**Objection to Planning Application 2024/5407/P & 2024/5423/L
Gardeners' Building, Highgate Cemetery (East Mound)**

Objections on Submitted Proposals for a Gardeners Building

HEIGHT OF THE TOP SECTION OF THE GARDEN BUILDING
AT IT'S TALLEST POINT FROM THE MOUND LEVEL
COMPARED WITH THE COLONADE HEIGHT

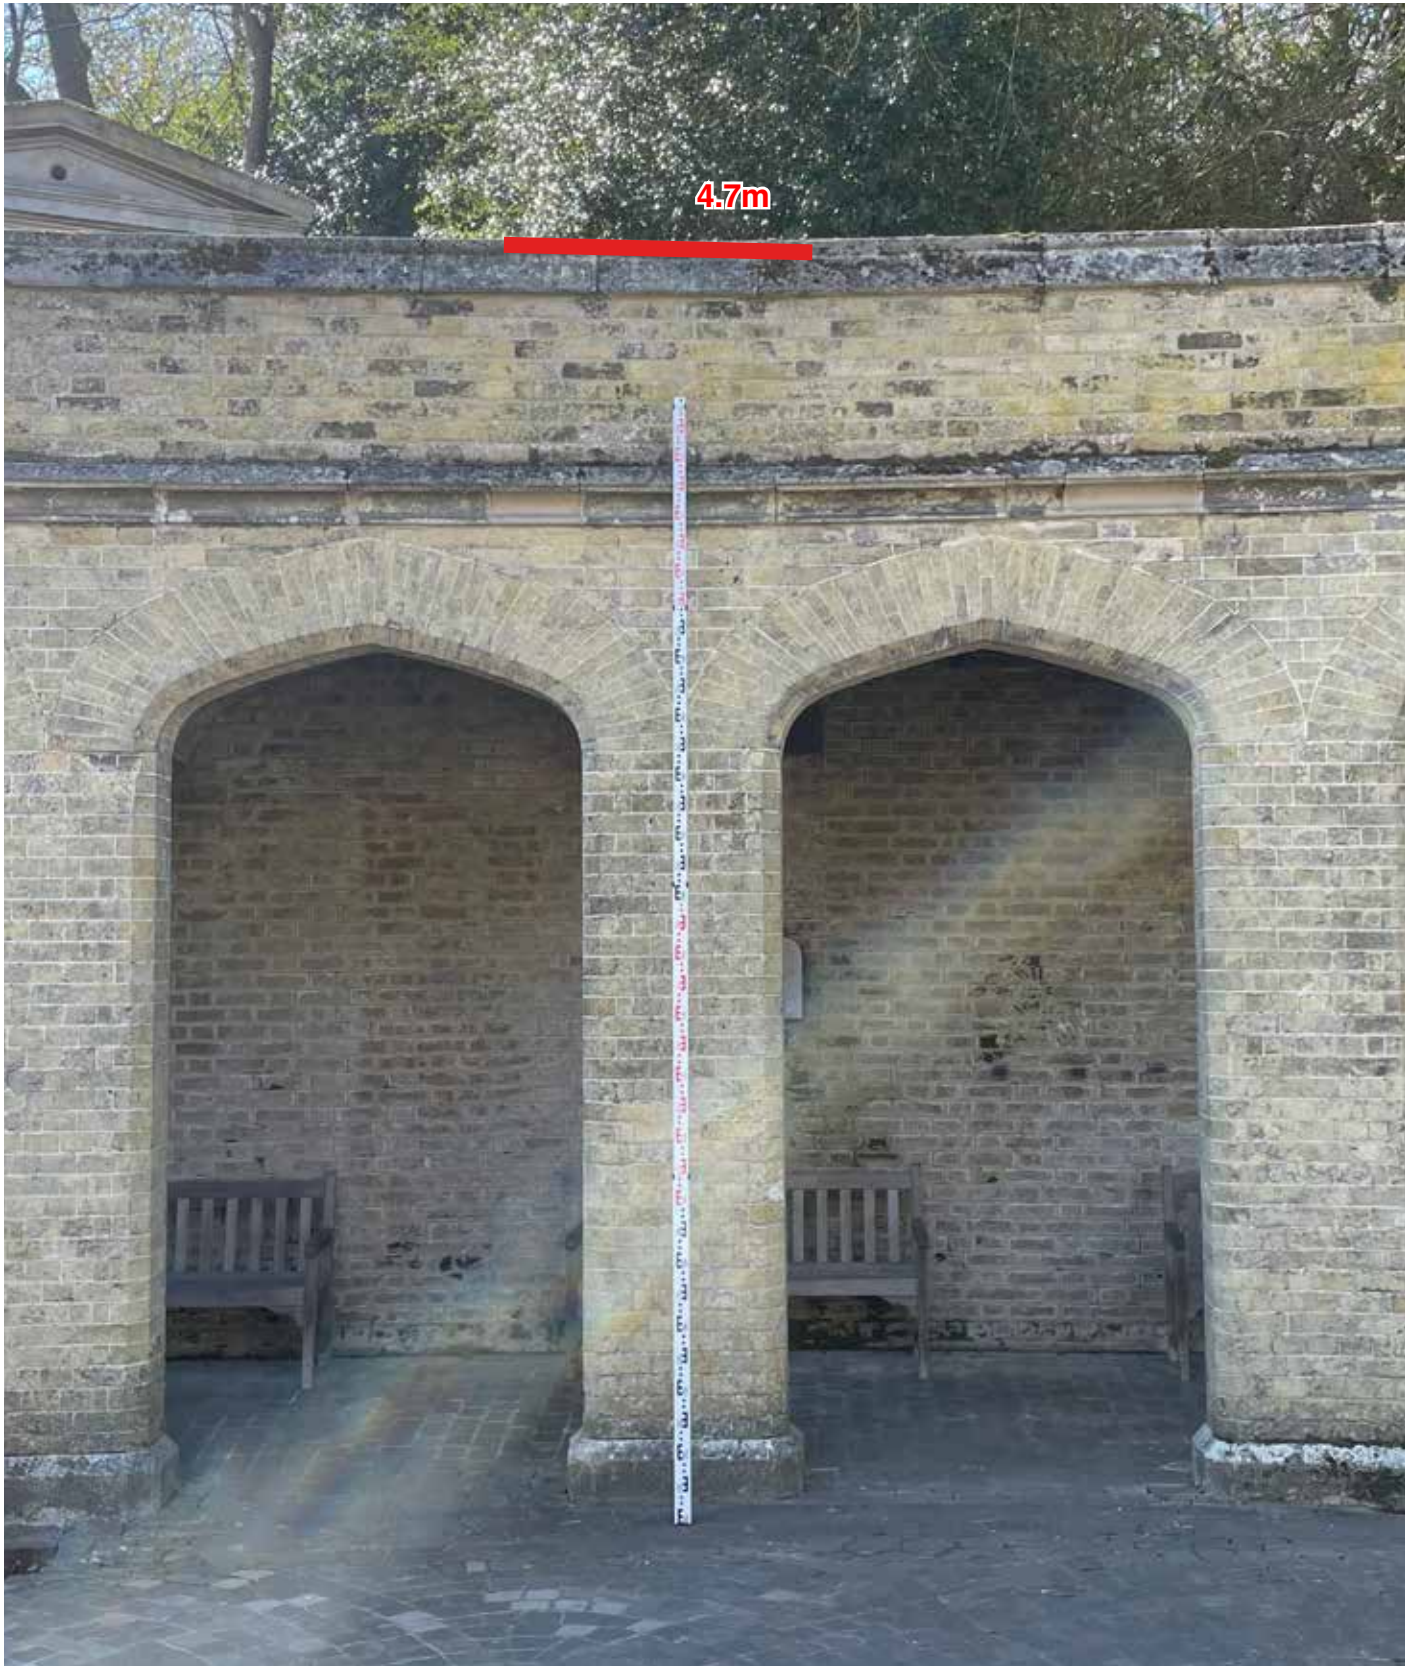
HEIGHT OF THE TOP SECTION OF THE GARDEN BUILDING
AT IT'S LOWEST POINT FROM THE MOUND LEVEL
COMPARED WITH THE COLONADE HEIGHT

PUBLISHED PHOTOMONTAGE IS MORE OF AN IMPRESSION THAN AN ACCURATE REPRESENTATION OF THE SCALE OF THE PROPOSED GARDEN BUILDING

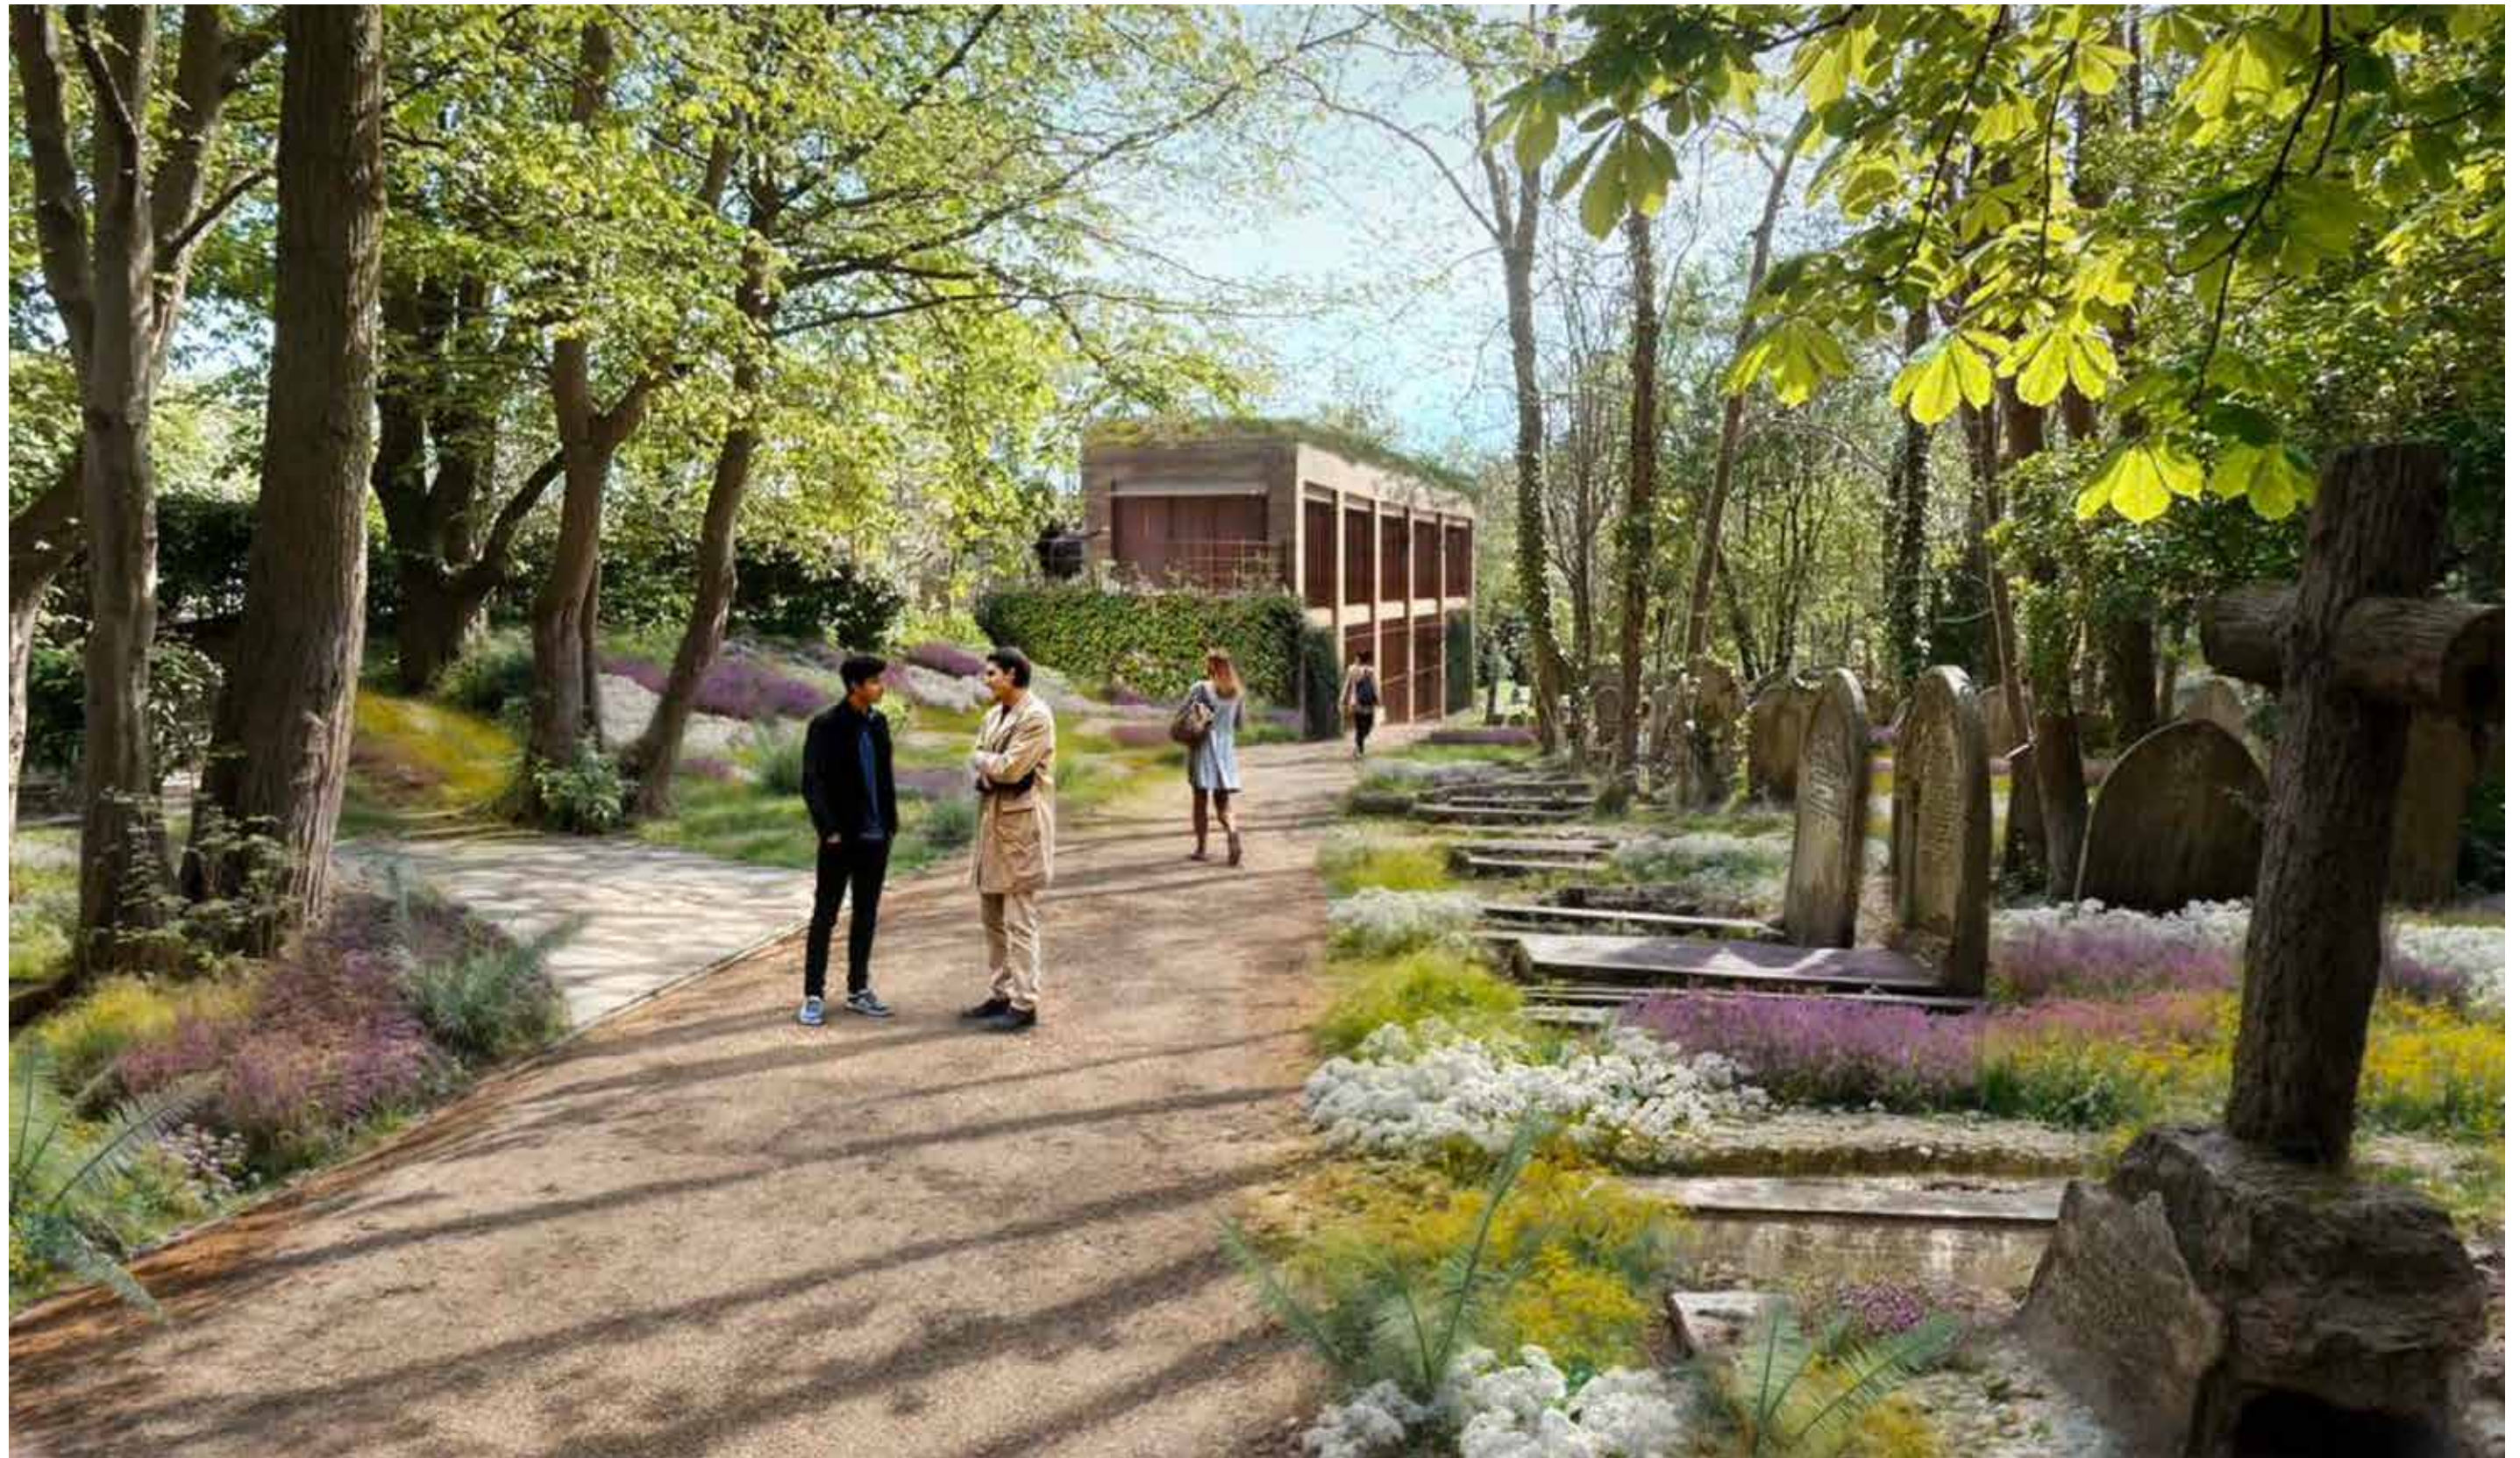
OUTLINE OF BUILDING AS SEEN FROM NEAR THE RAMP ACCESS TO THE MOUND

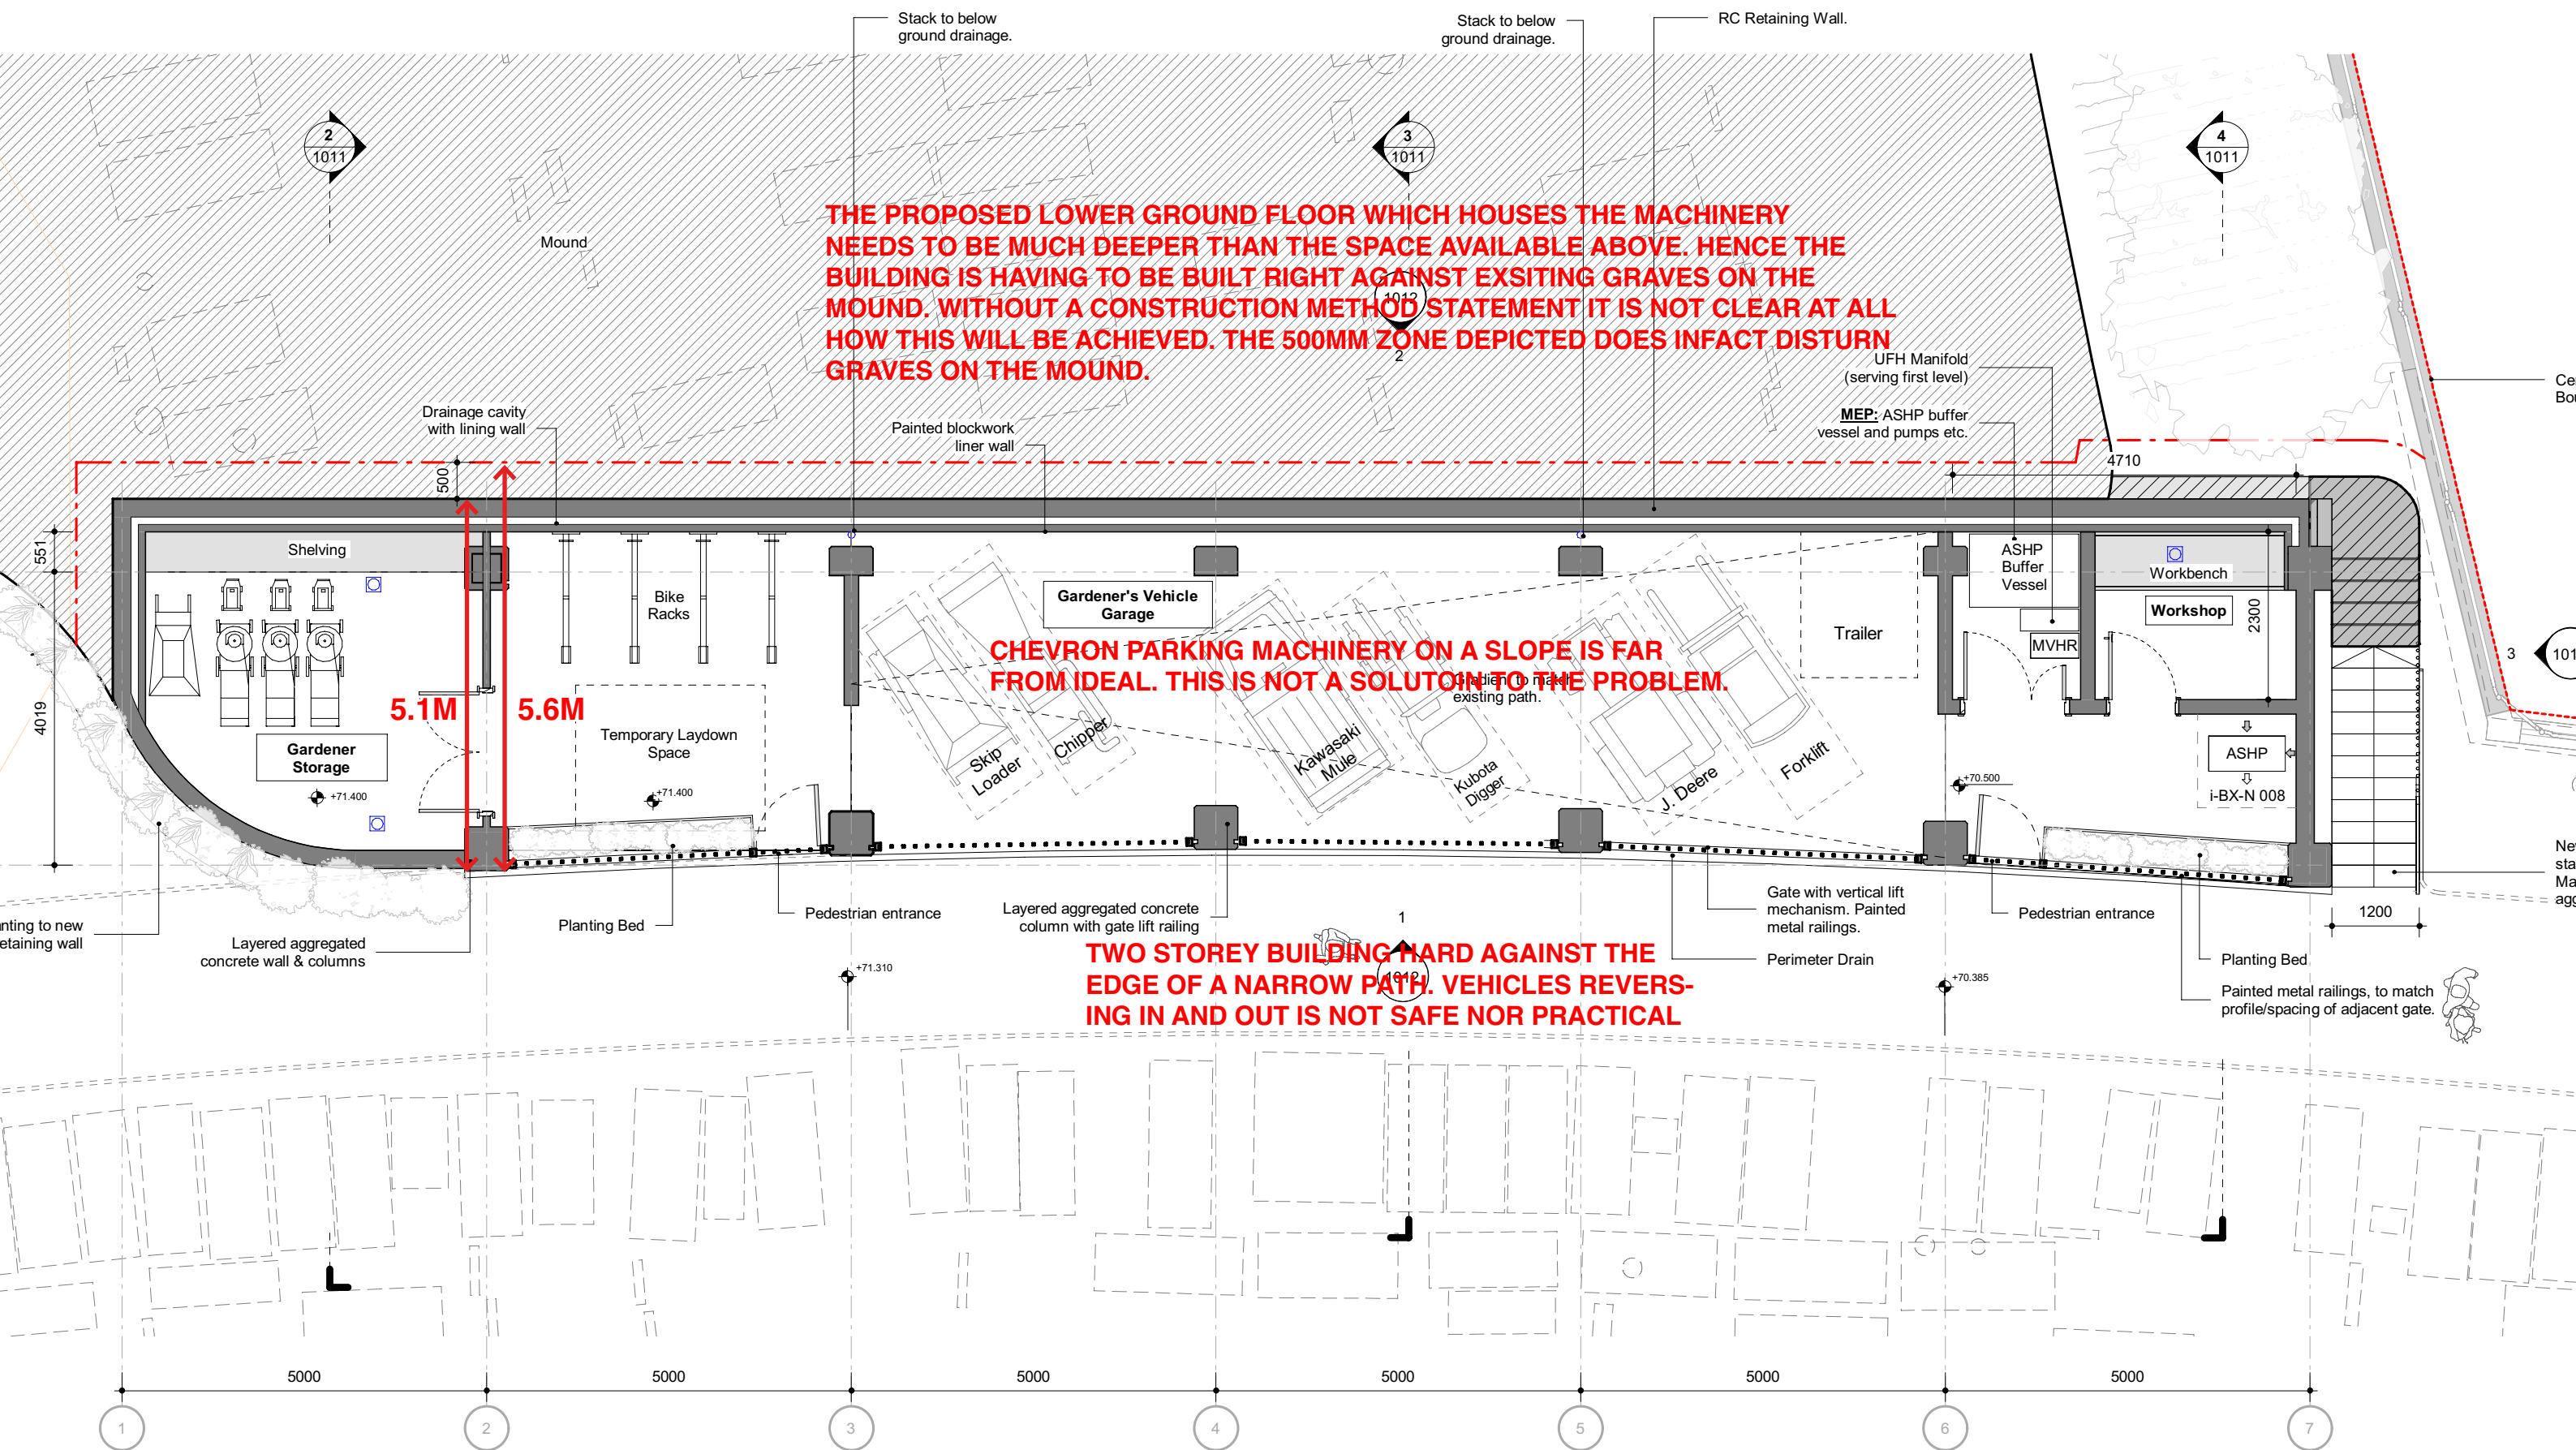
THE BUILDING DOES NOT FIT THE CONSTRAINTS OF THE MOUND. THE MOUND IS ONLY 3.9M DEEP.

- HOW CAN EXISTING GRAVES BE PROTECTED DURING CONSTRUCTION ?
- GRAVE OWNERS CANNOT ACCESS THE GRAVES WITHOUT THE PATH DURING CONSTRUCTION WORK
- THE PROPOSED PATH IS LESS THAN 1.1M IN FRONT OF THE SEATING AREA.
- WHEELCHAIR ACCESS IS MADE EXTREMELY DIFFICULT.
- A GENEROUS 1.5M PATH IS BEING REDUCED TO LESS THAN 1.1M
- A FUNERAL/CREMATORIAL WALL IS BEING CREATED. WHY?
- THE OPENNESS OF THE MOUND SETTING IS COMPLETELY ERODED WITH THIS PROPOSAL
- ACCESS TO THE TOILET AND STAFF AREAS FROM THE MOUND IS UNWELCOME
- THE STAIR ACCESS FROM THE SOUTH AND STAFF ENTRANCE IS NOT RESOLVED

**STAFF TRAFFIC HERE IS IN CONFLICT
WITH THE TRANQUILITY OF THE MOUND**
